Wollongong Local Planning Panel Assessment Report | 19 November 2020

WLPP No.	Item 2
DA No.	DA-2019/1290
Proposal	Mixed Use Development - demolition of existing structures and the construction of a shop top housing development comprising three (3) commercial tenancies, 100 place childcare centre, 50 residential units with two (2) levels of basement car parking.
Property	16-20 Belmore Street, Wollongong
Applicant	Urban Link Pty Ltd
Responsible Team	Development Assessment and Certification - City Centre Major Development City Centre Team (RW)

ASSESSMENT REPORT AND RECOMMENDATION

Drawing Title
ELEVATIONS
NORTH ELEVATION

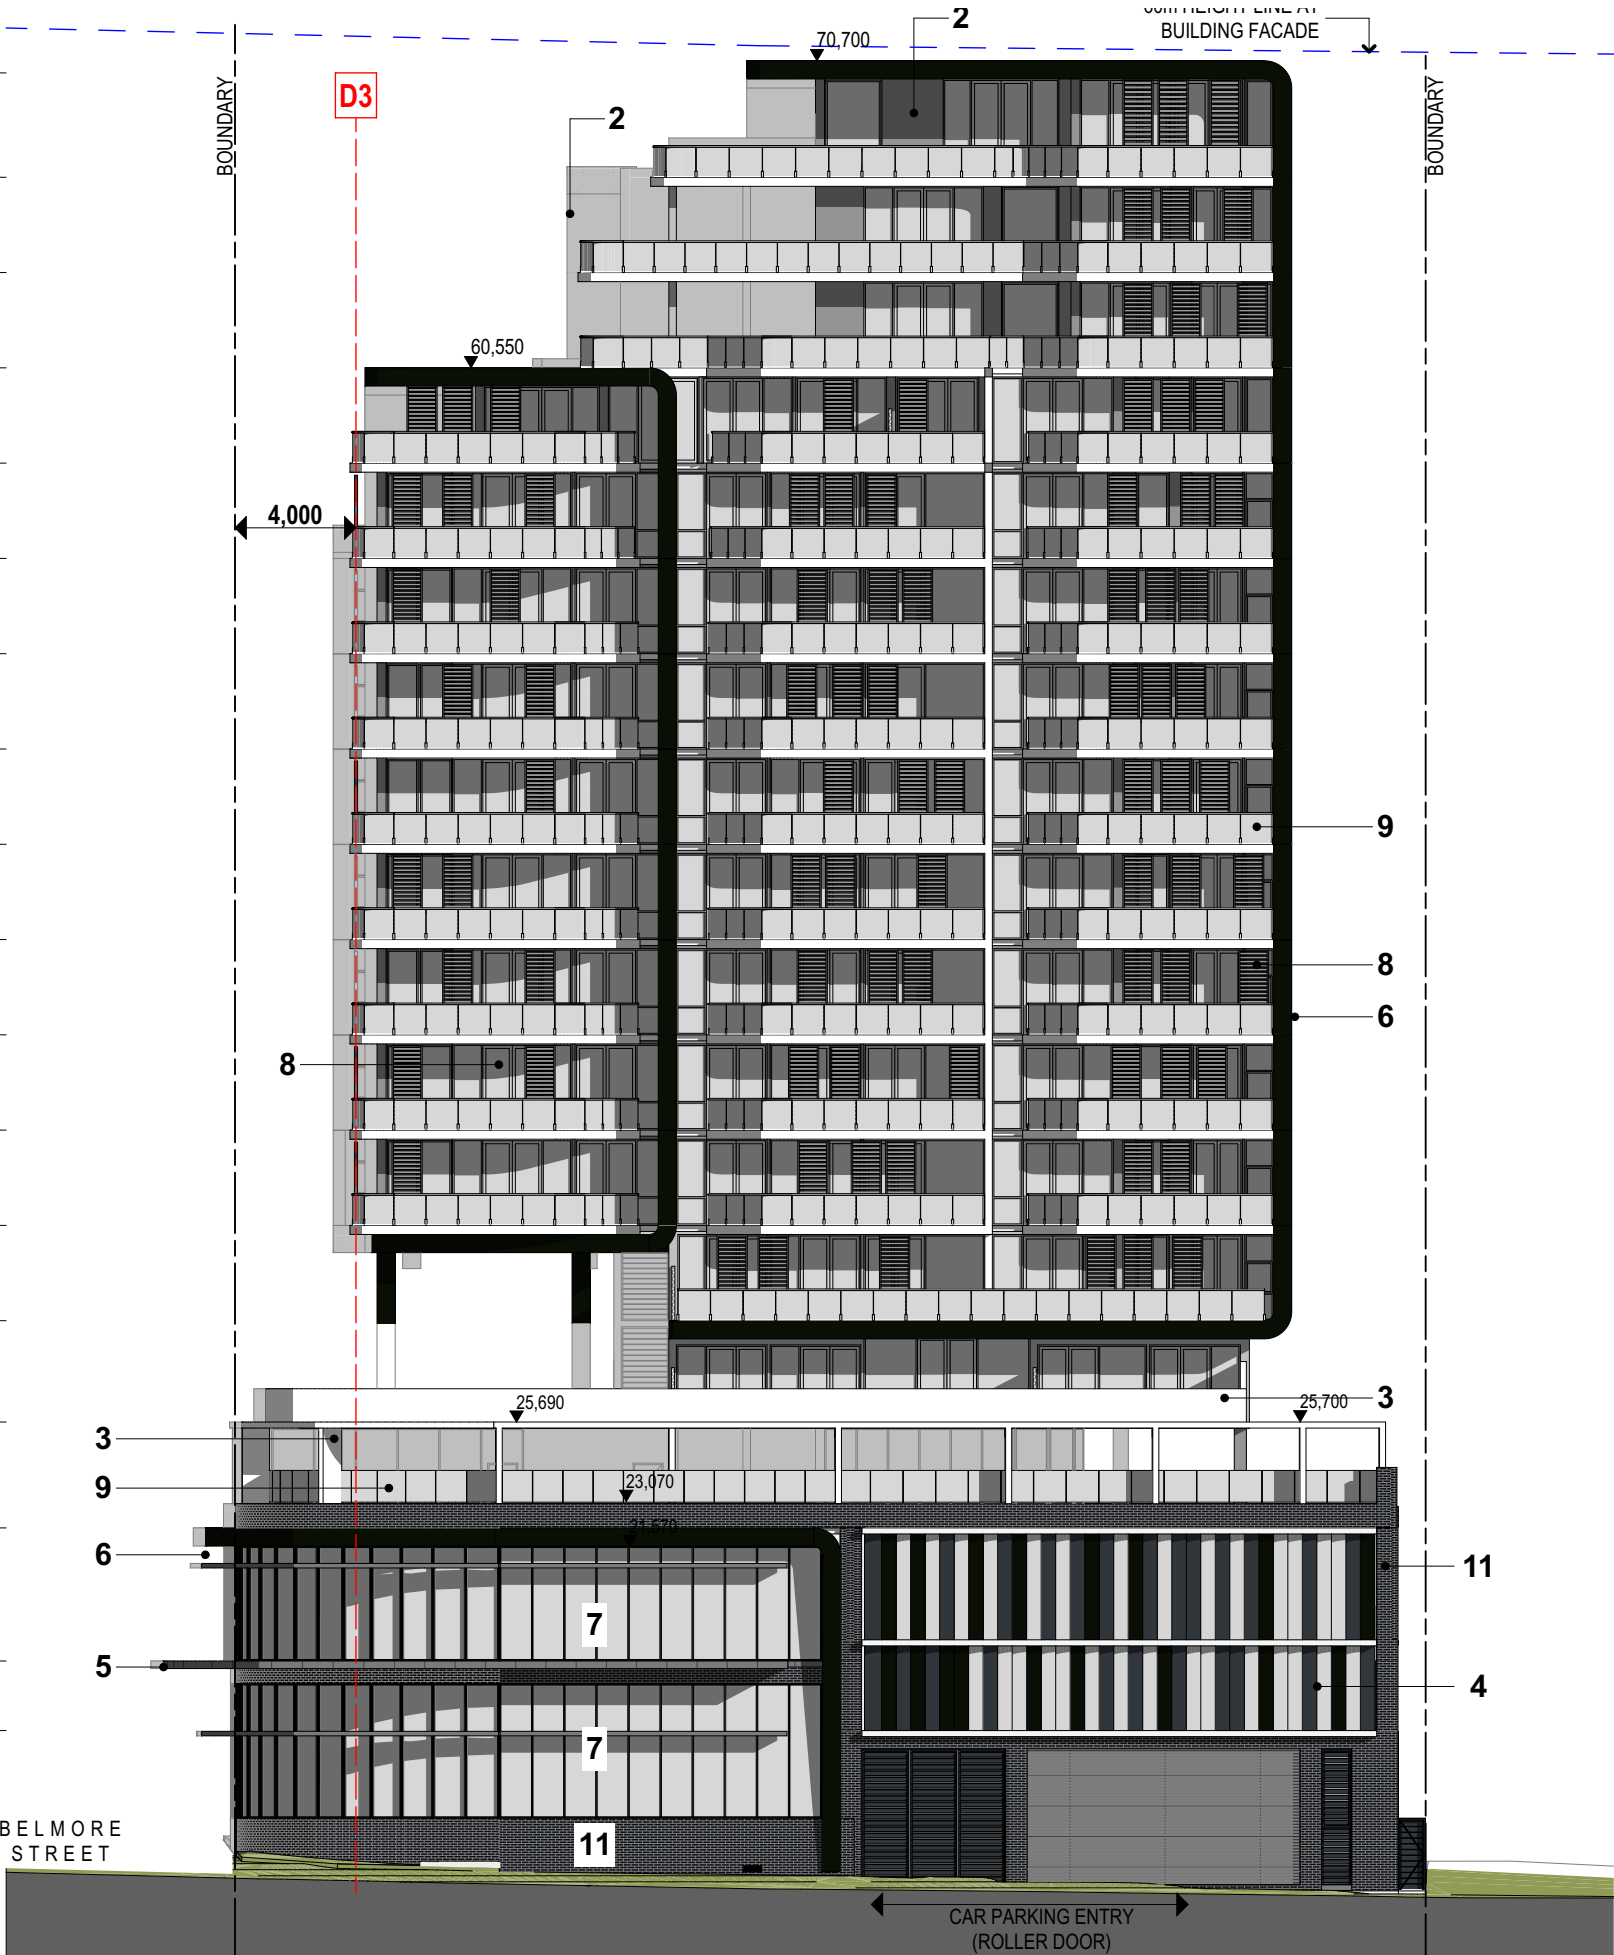
Concerns were raised over the treatment of the podium noting that the podium will be visibility from the north (Victoria St), the west (rail corridor) and the south (until the adjoining sites are redeveloped). The revised plans have introduced more detailing into the basement podium on these elevations, incorporating aluminium blades in 3 shades of grey that allow some visibility into the car parking space and also incorporating face bricks. A comparison of the design considered by the DRP and the current plans is shown below:

This concern primarily related to the northern elevation which previously incorporated three vertical elements into the design. The northern elevation has been revised to reflect the recommendation of the Panel now largely being expressed as two linear forms comprising a smaller tower and the larger tower element:

Figure 3a: Revised design of northern elevation (Victoria St)

Figure 4: Revised northern elevation
